RADIOLOGIC AND ENGINEERING ASSESSMENT

DOE ID NO.: GJ-08841-RS  
ADDRESS: 2519 SOUTH BROADWAY

APRIL 1985  
REVISED AUGUST 1985

The following is in response to your questions and comments during the Technical Review concerning Department of Energy (DOE) Identification (ID) number GJ-08841-RS (2519 South Broadway).

HOLE NUMBER: 9

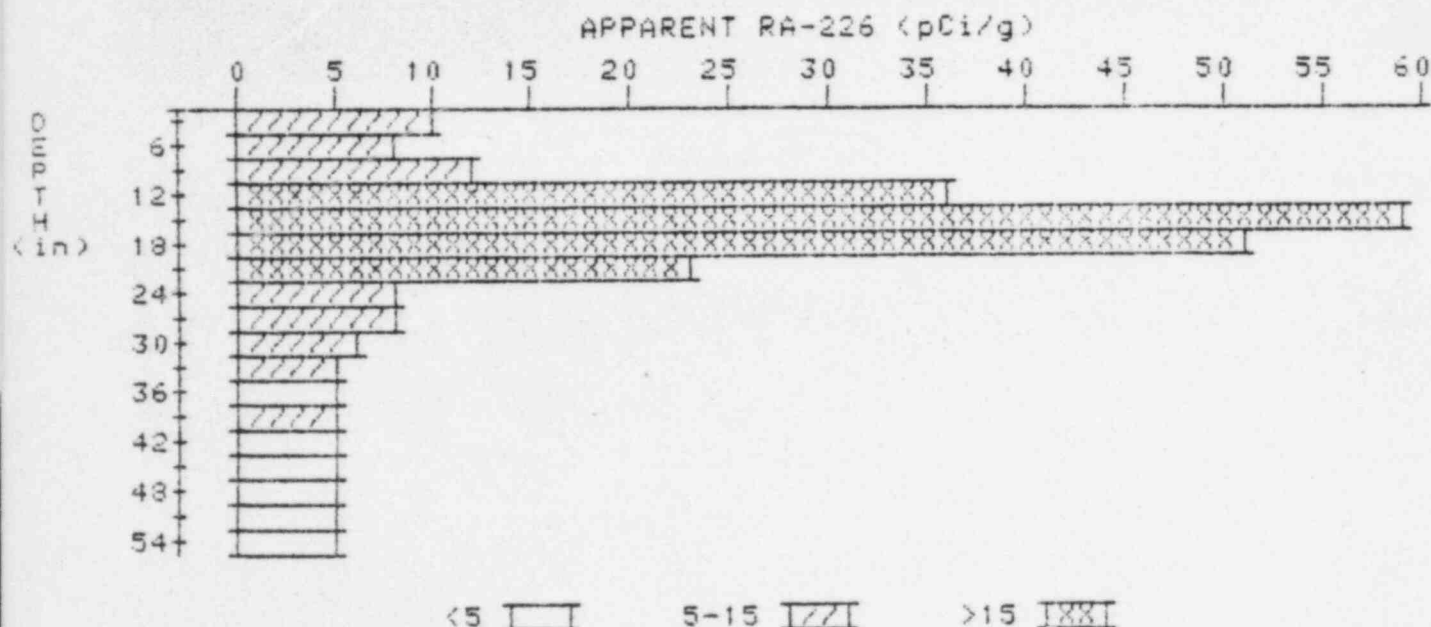
In response to your letter of April 5, 1985, I wish to clarify my original comment in the April 2 letter. I was suggesting that the possible septic tank on this property (#08841) be located and adequately investigated for possible contaminated involvement. If you feel that you have already performed this documentation, then the assessment data package should reflect this fact.

In reference to your letter dated 15 April 1985, borehole number 9 (location number 216223) was drilled to investigate, where the owner indicated the location of the septic was. I feel this is adequate and the assessment data package has been changed to reflect this.

HOLE NUMBER: 26

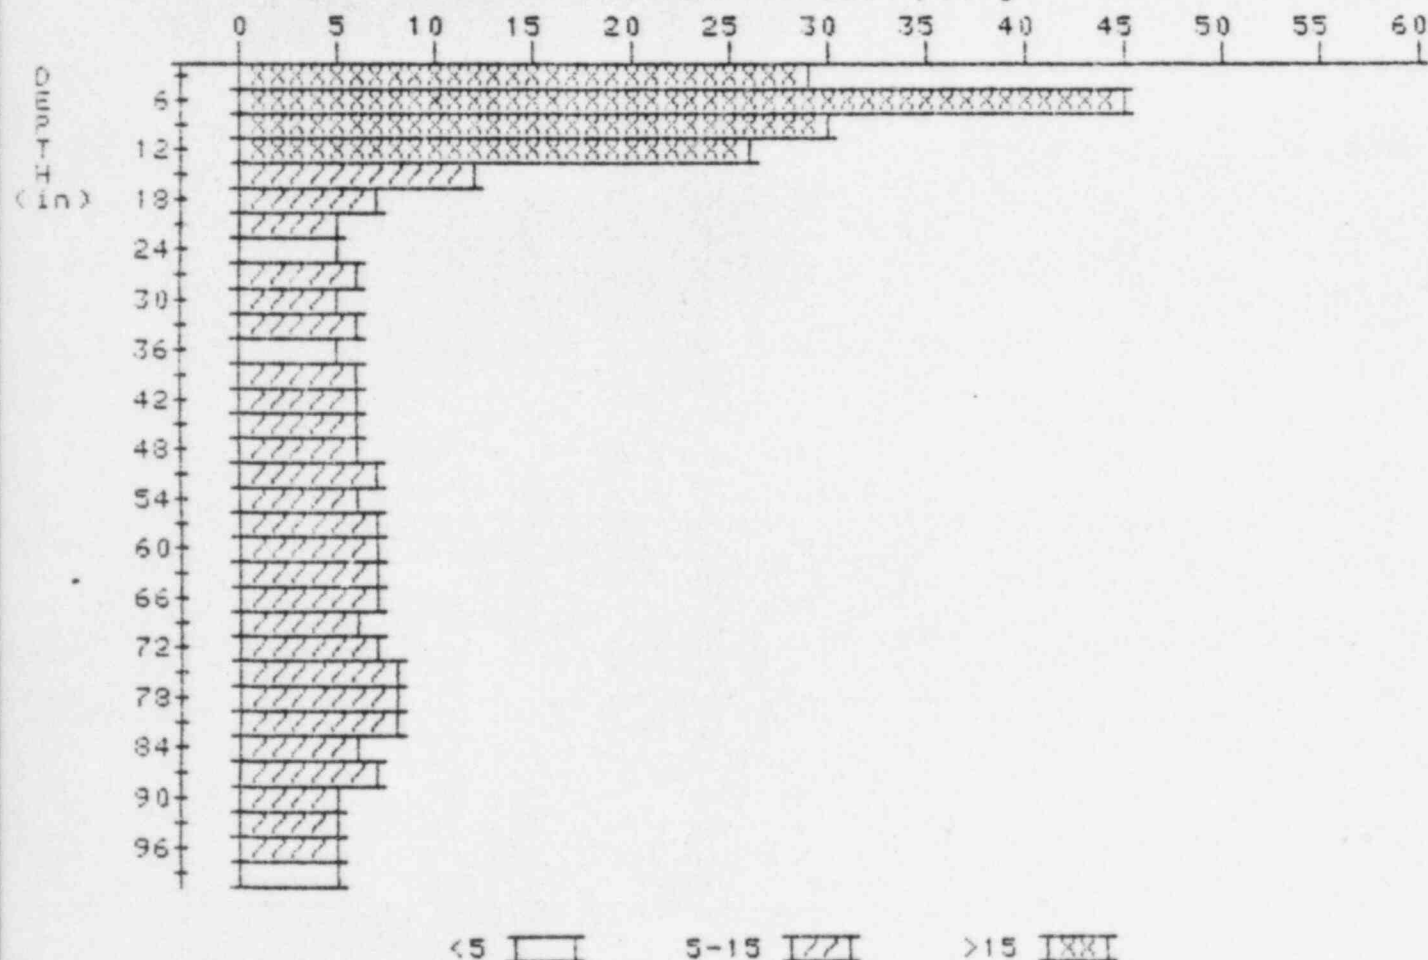
Your comment #3 stating that the possible "secondary radiation" exhibited between approximately 42" and 87" depth in borehole #26 (255237) was caused by a contaminated deposit on the adjacent property may in fact be correct. It is still recommended, however, that the location and possible contaminated involvement of the septic tank on this property (which may or may not be providing a shine contribution for this borehole) be adequately documented.

Borehole number 26 (255227) in question is close to the clean out part of the septic tank on the adjacent property, the probable area of contamination. This property, (DOE) (ID) number GJ-00842-RS, (2521 South Broadway) has been received by this department for assessment. This area will be investigated further during the assessment.
